**Title:** Permit 20-455: St. Stephen's Episcopal Church - 4439 West 50th St., Edina

**Prepared by:** Name: Tom Dietrich  
Phone: 952-473-2855  
tdietrich@minnehahacreek.org

**Recommendation:**

NO SCALE

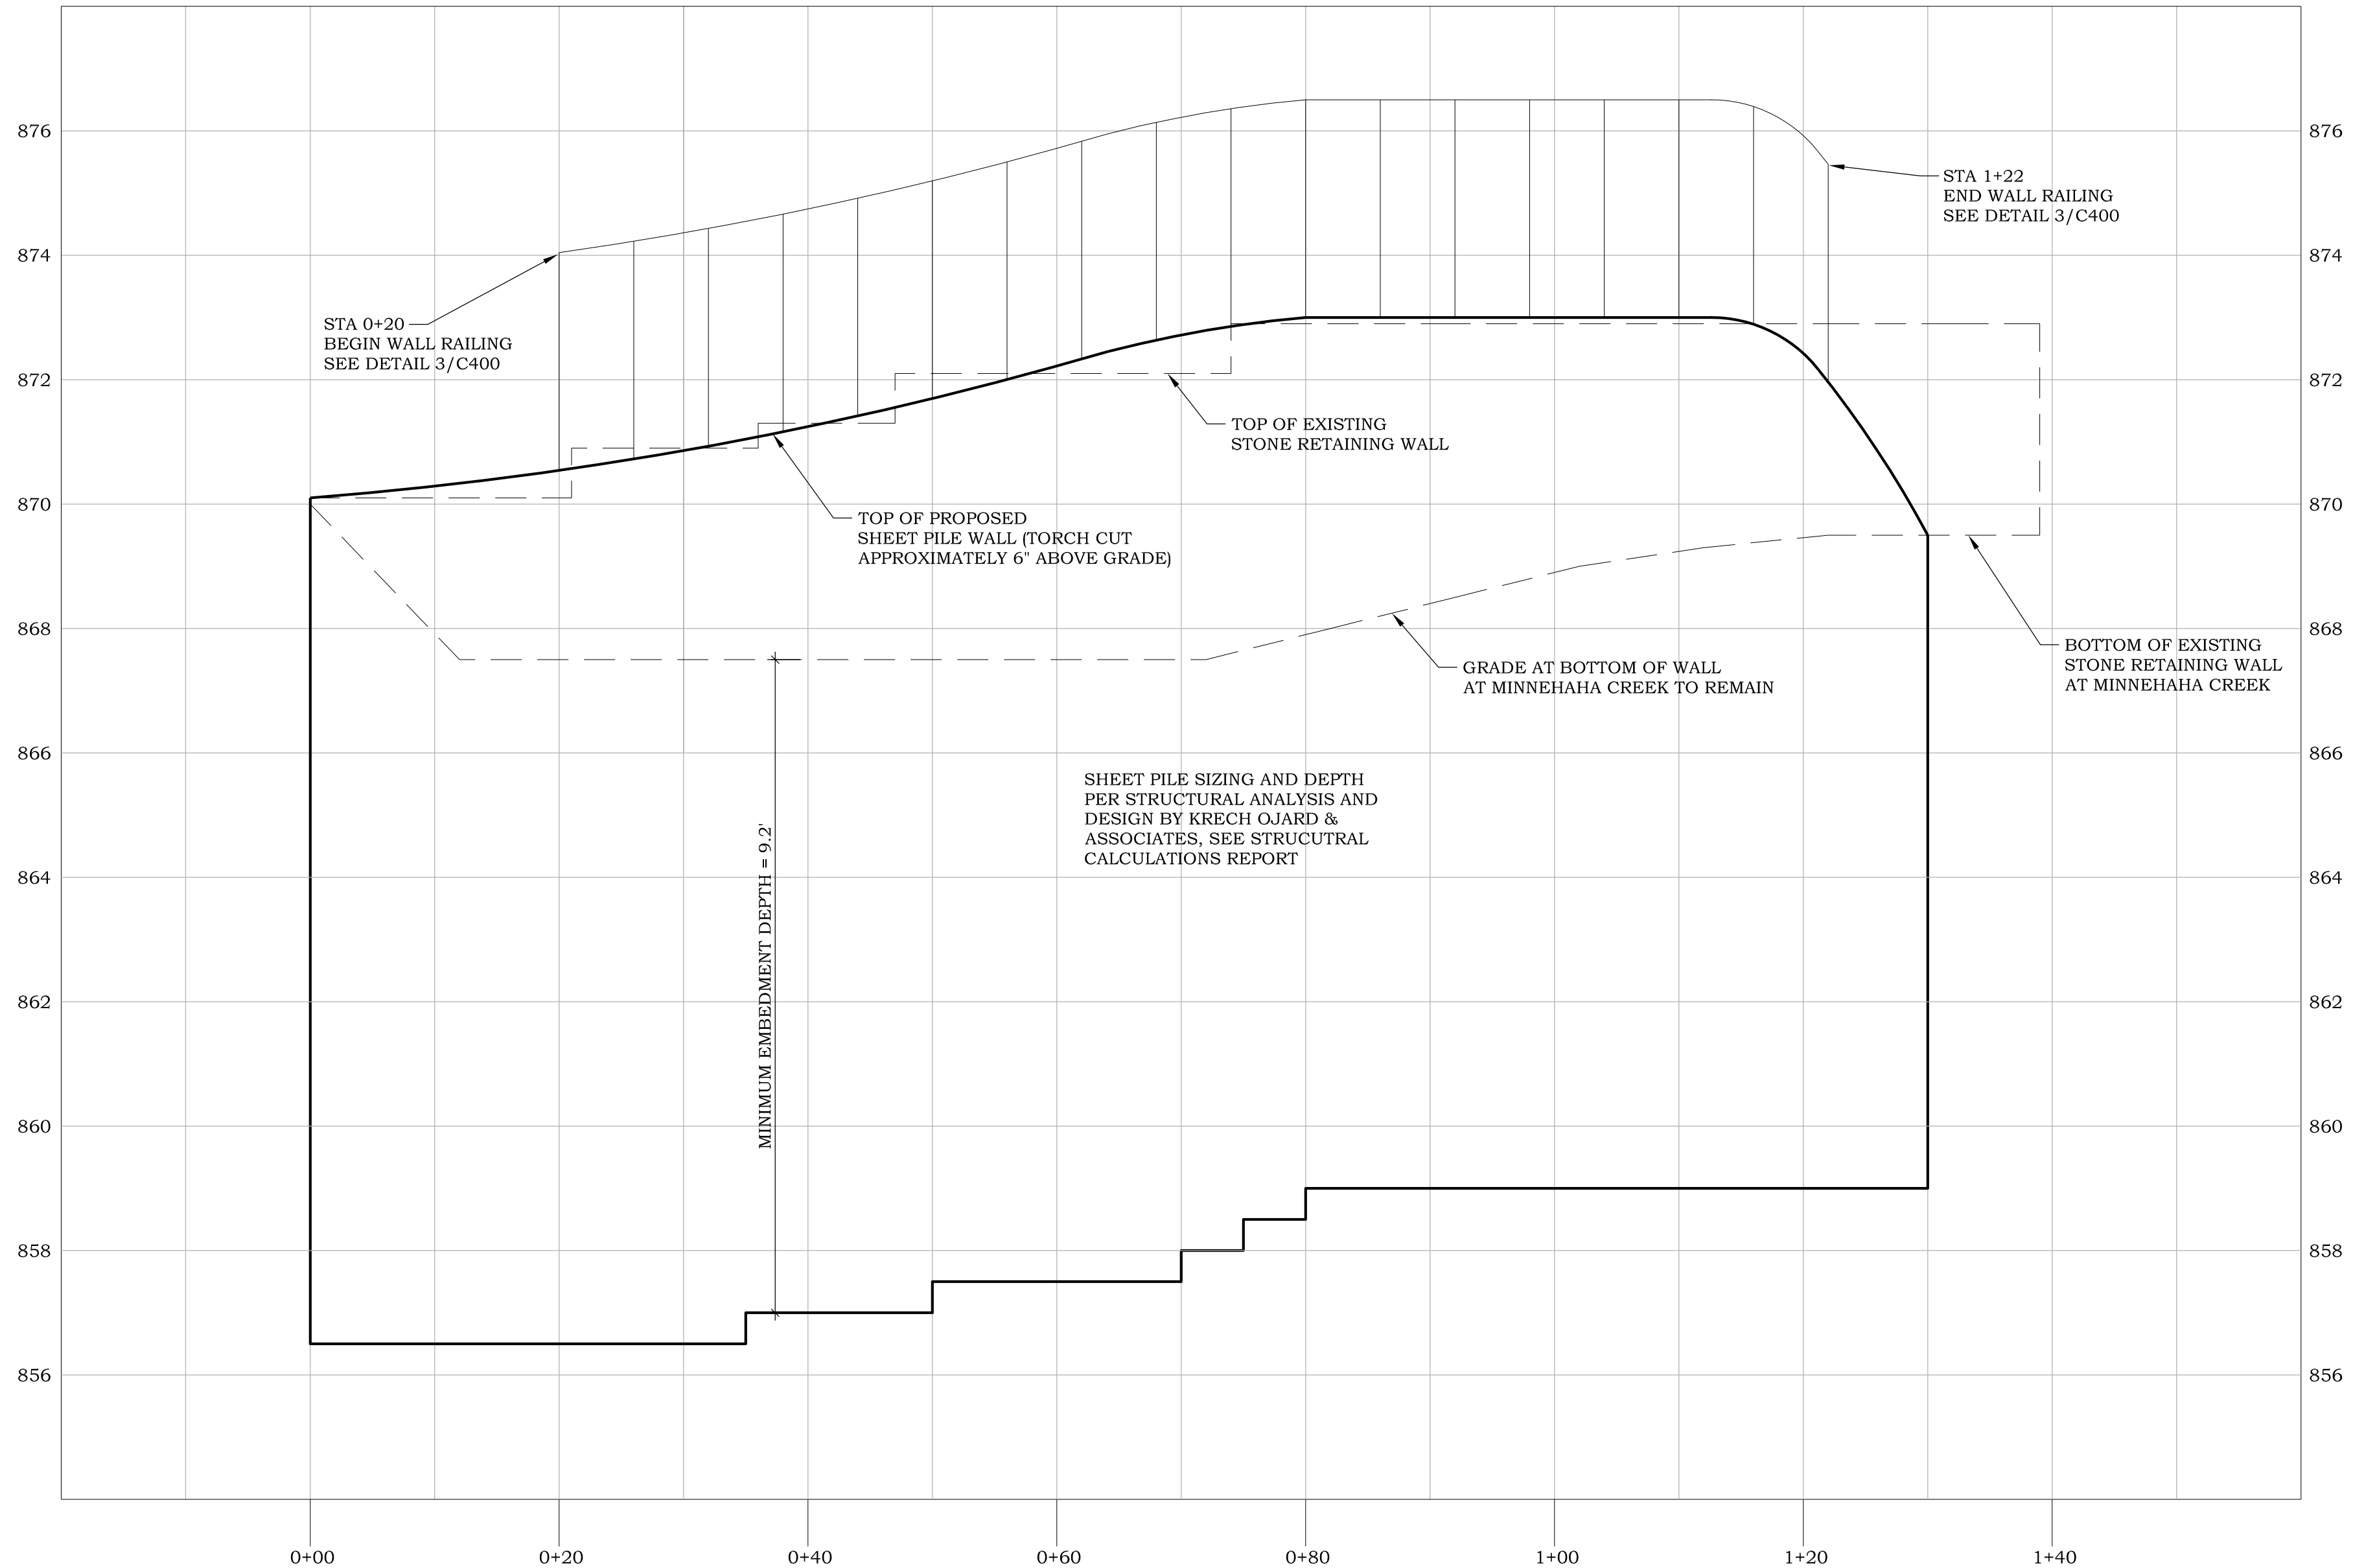
The District's Shoreline and Streambank Stabilization rule regulates alterations and improvements to the banks of a watercourse. The project is proposing to replace approximately 145 feet of stone retaining wall with 0.4 inch-thick sheet pile wall. Additionally, the Applicant is proposing to place hard armoring at the base of the wall to protect the new structure from future scouring and potential damage. Because the replacement of an existing shoreline stabilization practice is proposed, the rule is triggered. For clarity, analysis of the shoreline practices has been separated into two sections – 'hard armoring' and 'retaining wall replacement', detailed below.

As noted above, the Applicant is proposing to replace 145 feet of existing stone retaining wall with 0.4-inch-thick sheet piling. Installation of the sheet piling will occur immediately in front of the existing stone wall. Once the sheet piling is in place, the top 1 – 2' of the existing stone blocks will be removed, and backfilled with sand and top-soil. Section 10 of the District's Shoreline and Stabilization rule outlines four primary provisions when evaluating retaining wall proposals.

The placement of the sheet pile wall in front of the existing stone retaining wall, will on average, reduce the channel width by one foot. The existing channel width is approximately 38 feet wide, and will be reduced to 37 feet in width. The reduction would reduce the effective flow area by about 2.5% in this section of the creek. Although there is a 2.5% reduction in the effective flow area at the project location, the channel maintains a greater than 200% effective flow area comparative to the Wooddale Ave. bridge opening, immediately upstream of this location. The bridge opening at 17.5 feet wide, is the restricting hydraulic constriction for this section of Minnehaha Creek. Therefore, the reduction in channel width at the project location will not represent a hydraulic constraint, and will maintain 100-yr high water levels both upstream and downstream of the project location. Additionally, the encroachment within the floodplain will be offset by grading directly downstream of the wall to provide a 1:1 floodplain mitigation volume, which ensures that no floodplain storage is lost in this section of the creek. Based on this information and the District Engineer's review and analysis, the reduction of channel width in this area will have no effect on upstream or downstream 100-year high-water levels. Therefore, section 10(a) of the rule has been met.

As a component of the project, the Applicant is proposing to utilize hard armoring at the base of the sheet pile retaining wall to protect the structure from scouring and associated damage. An analysis of the proposed hard armoring under the District rule is outlined below.

- 6(a)(3) – stabilization practices must be installed at a 3:1 slope or flatter where practical and feasible.
  - Based on the plans and specifications supplied by the Applicant, the hard armoring will be installed at a 3:1 slope. Therefore, this criteria has been satisfied.

1. Submission of a survey prepared by a registered land surveyor identifying the location and elevations of the finished wall.

Section 10(d) of the District's rule outlines that the applicant must submit a survey prepared by a registered land surveyor location the finished wall and shall file a certificate of survey with the District. This requirement has been included as a stipulation at the top of this report.
